RE: Chase Bank -1574 Woodbury Ave
TAC Comments

We are in receipt of an Application Review prepared by your office, dated March 3th, 2020. The following are responses to the previously mentioned comment letter:

DOCUMENT
SITE PLAN APPROVAL FOR CHASE BANK
SITE LOCATION
1574 WOODBURY AVENUE,
PORTSMOUTH, NH
03801

SHEET NO.
C-4

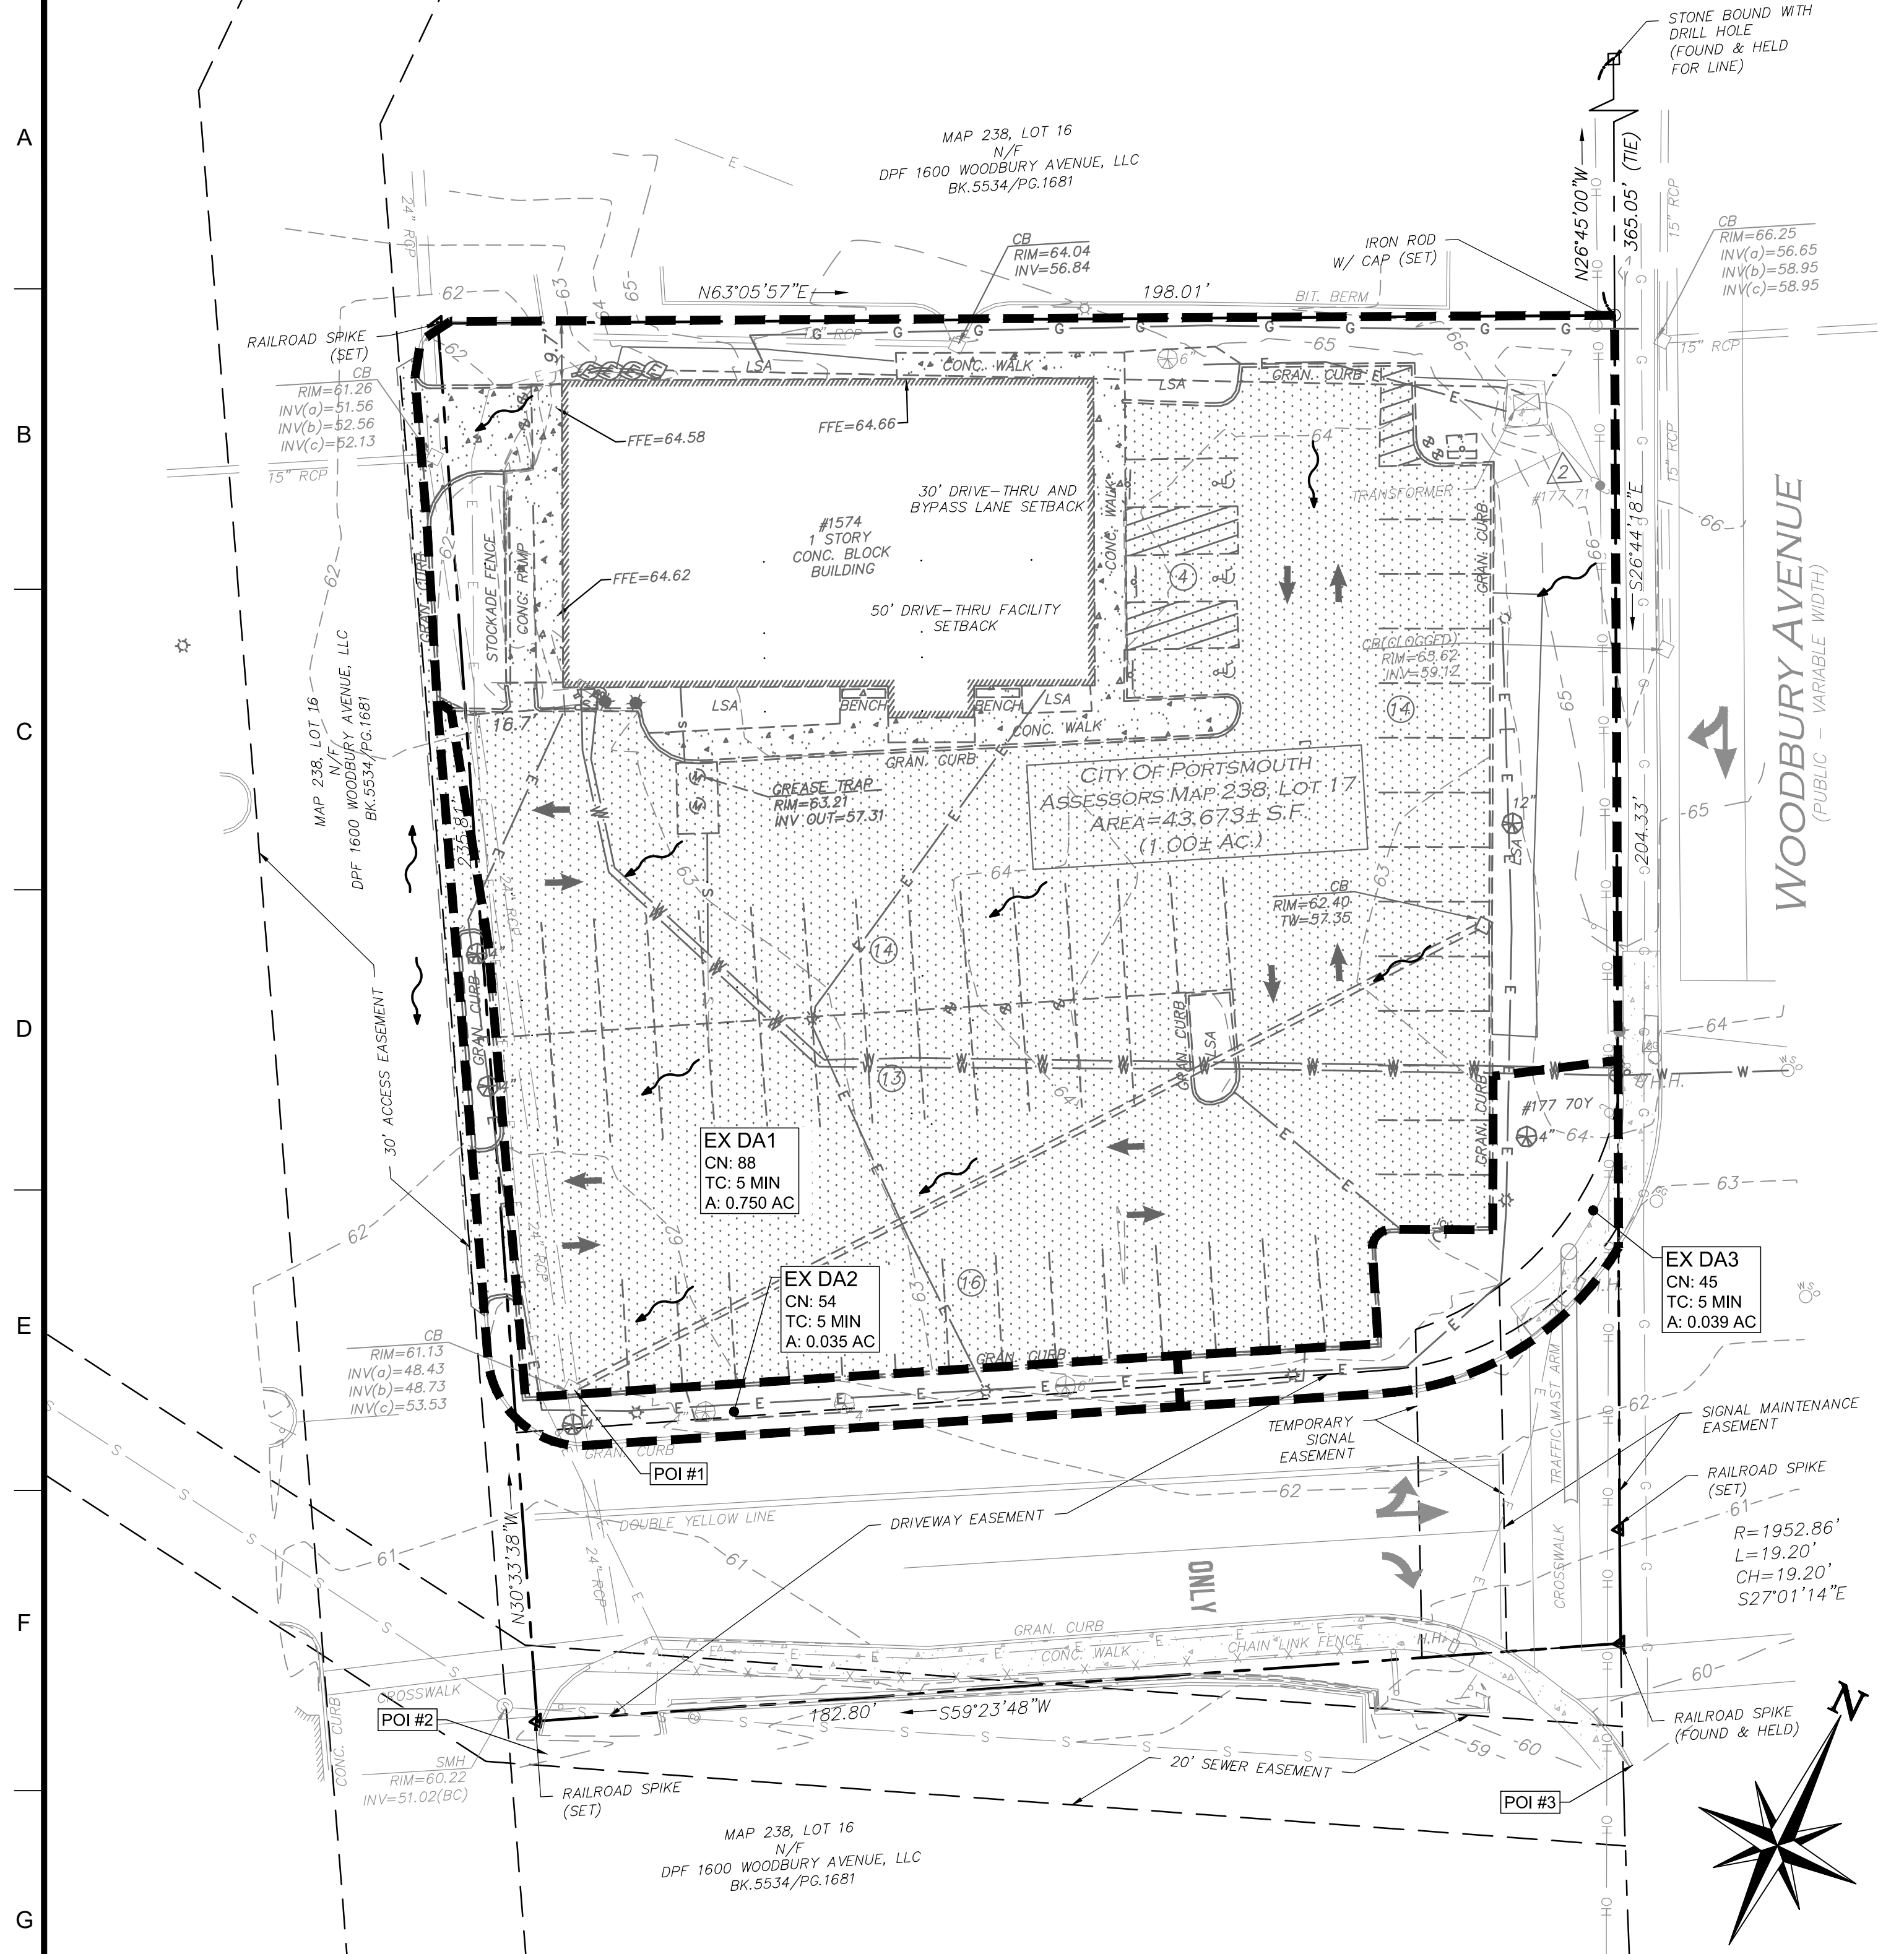
Comment 1 Existing utilities (water, fire suppression, storm drain, sewer, gas, power, communications) should all be reused. These will need to be shown in a more complete way on a plan of its own for clarity.

Response 1 **A proposed utility plan has been provided, see sheet C-4.**

LIGHTING PLAN MEASURED AT GROUND LEVEL
SCALE 1" = 20'

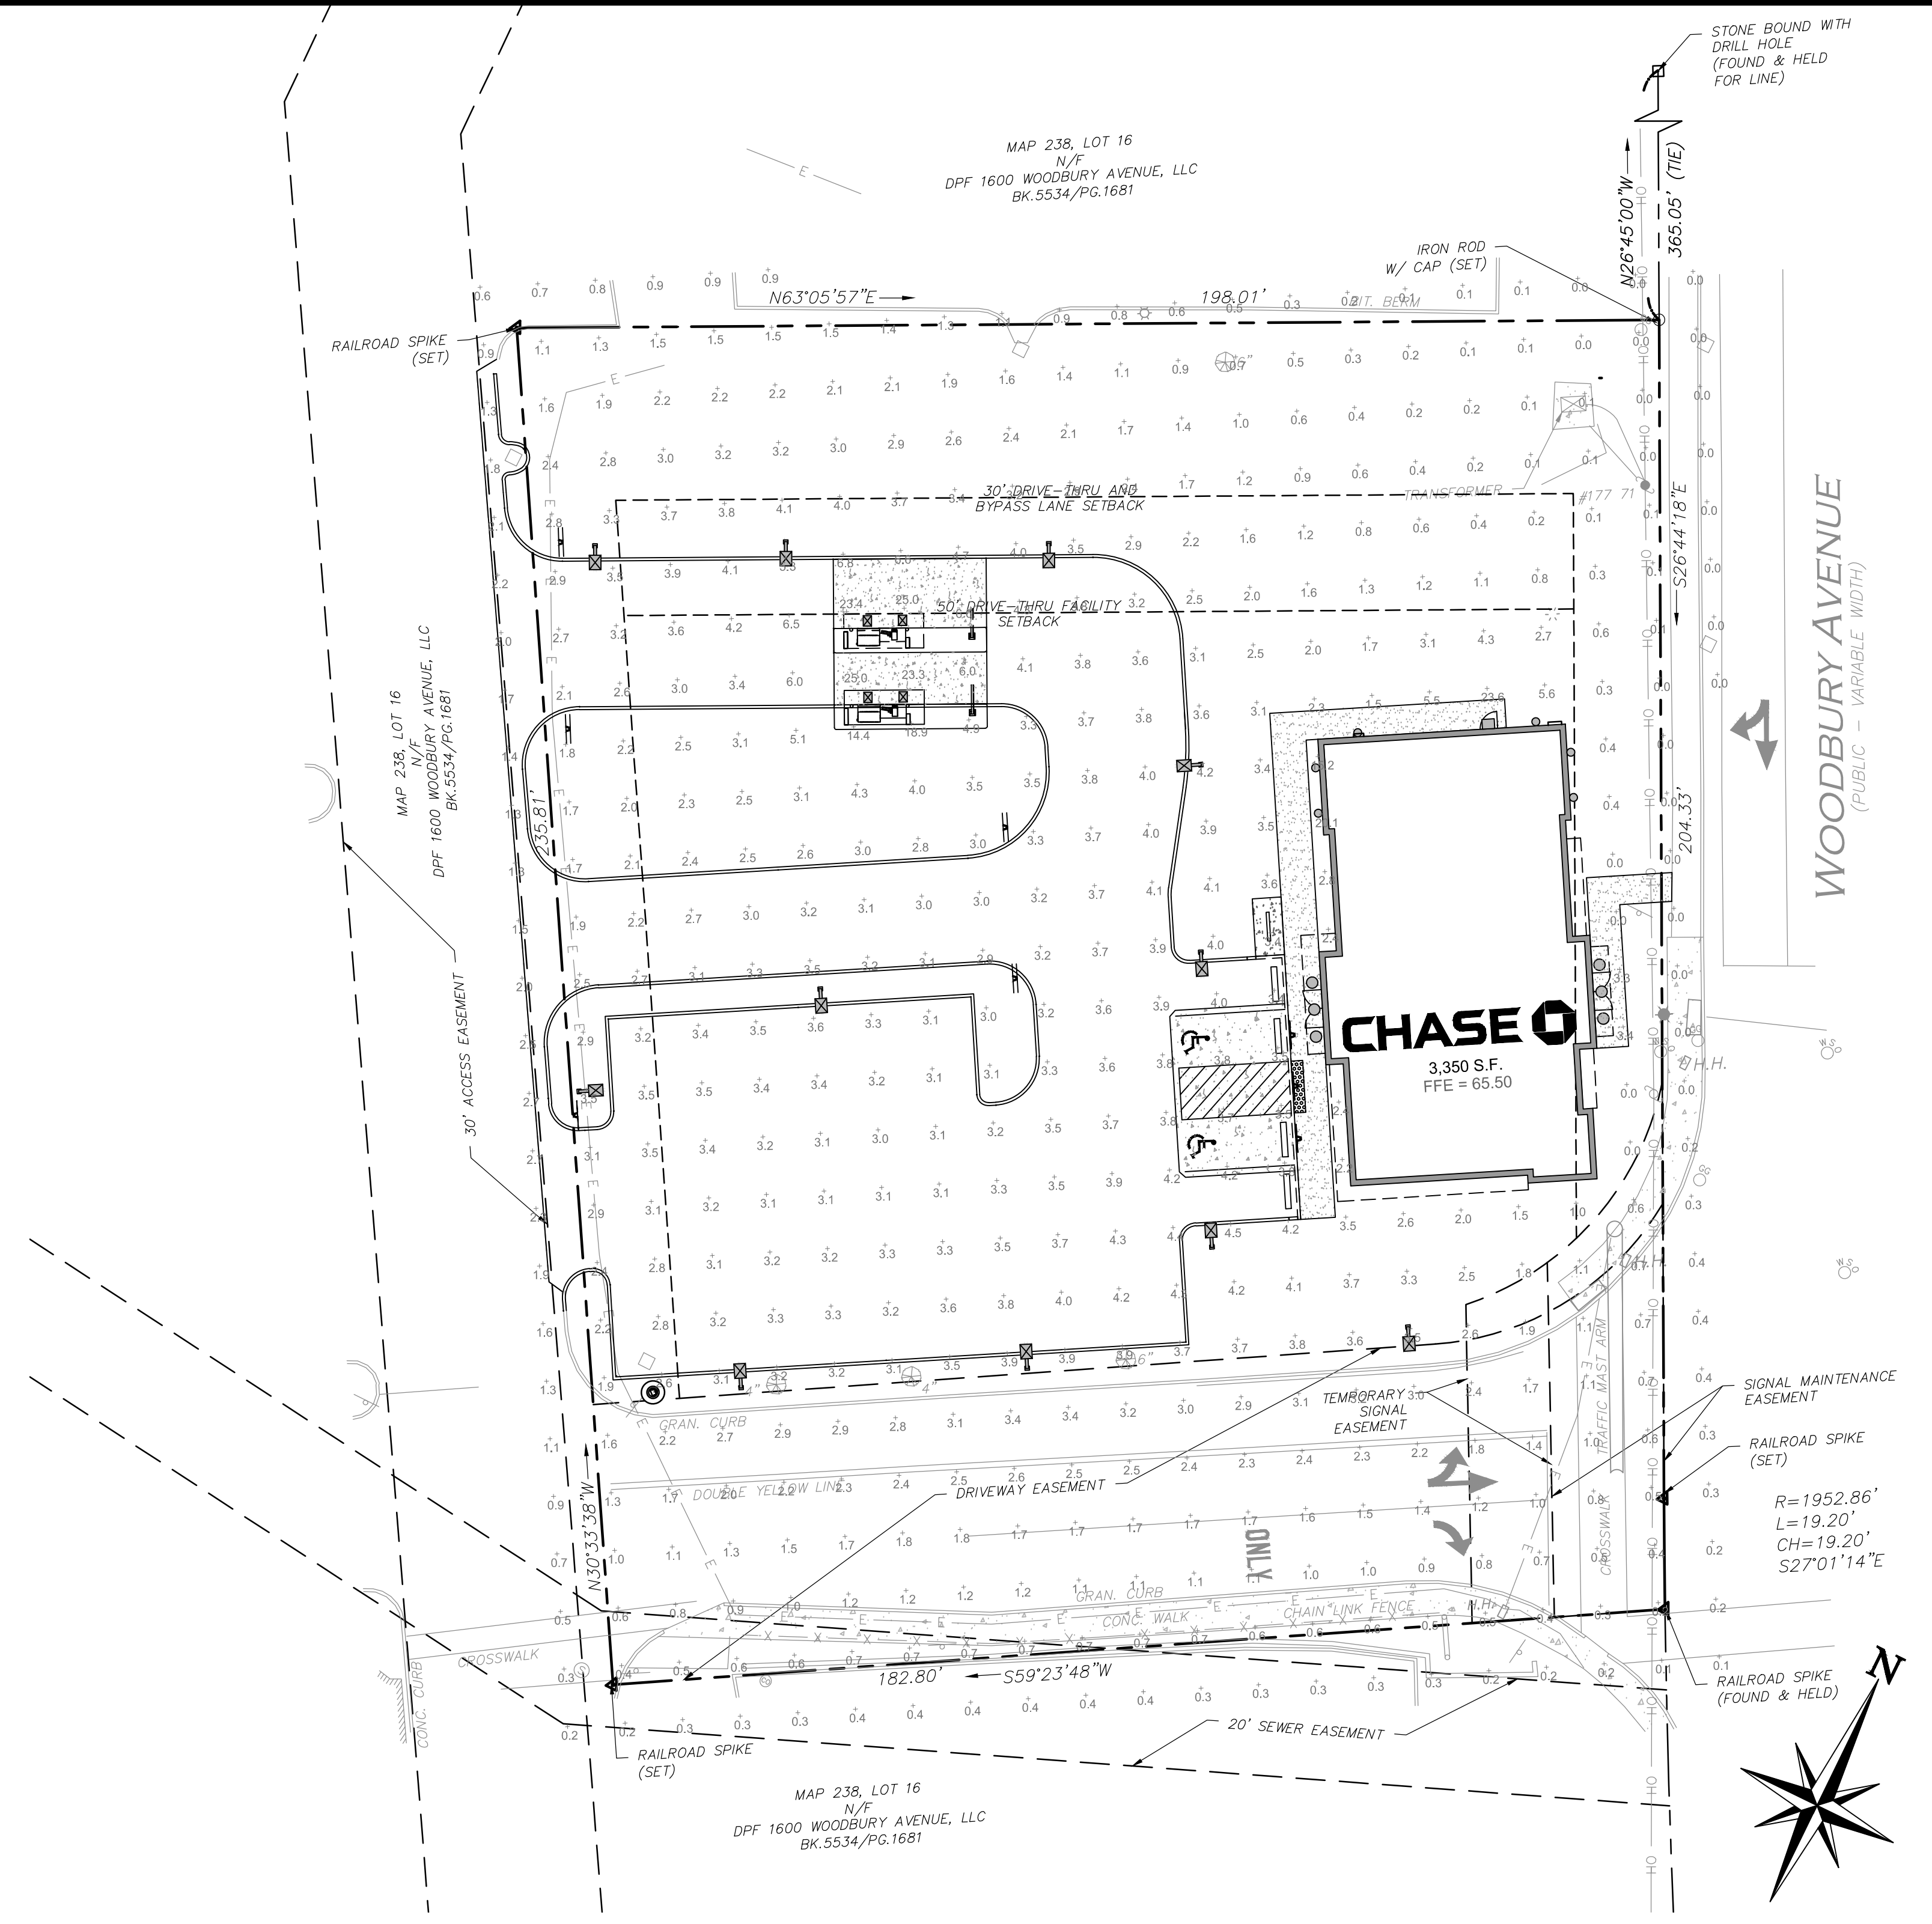
- Comment 7** Is there a lighting plan?
- Response 7** A lighting plan has been added, see sheet C-8 & C-9.
- Comment 8** Storm drainage and sewer pipes not being reused should be either removed or flow-filled.

ARRO LAYOUT 1E
2015-4-CDS
5756 / 5756

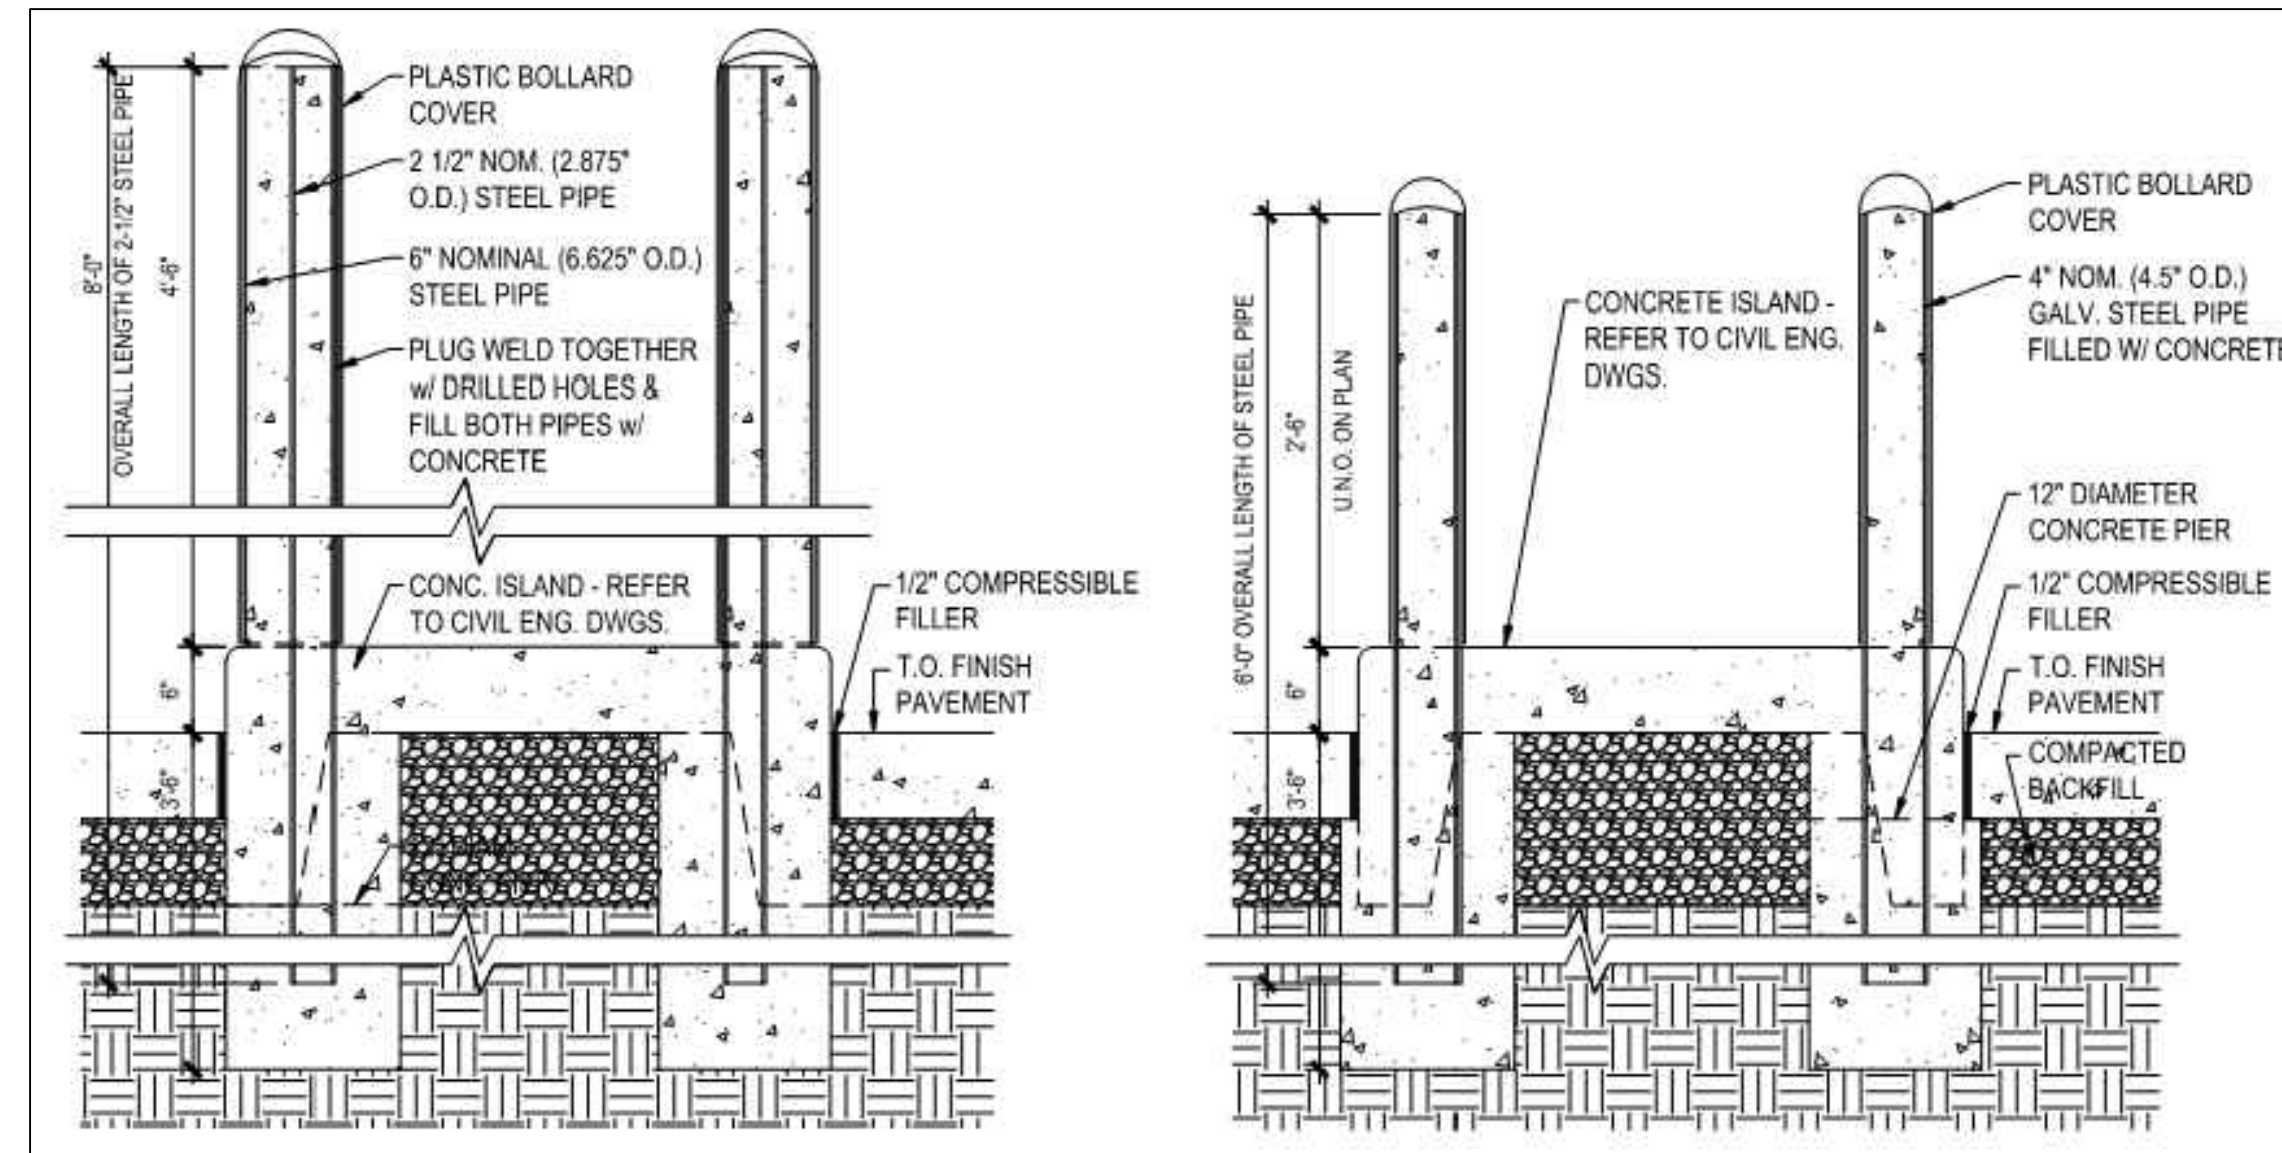
Comment 5 How is stormwater being treated to remove pollutants?

- Response 5** The project intends to install a new water quality structure designated as a CDS Unit by Contech, which meets the state's requirements for 80% TSS removal rate. It will be installed within the existing storm conveyance system, refer to stormwater report for details.
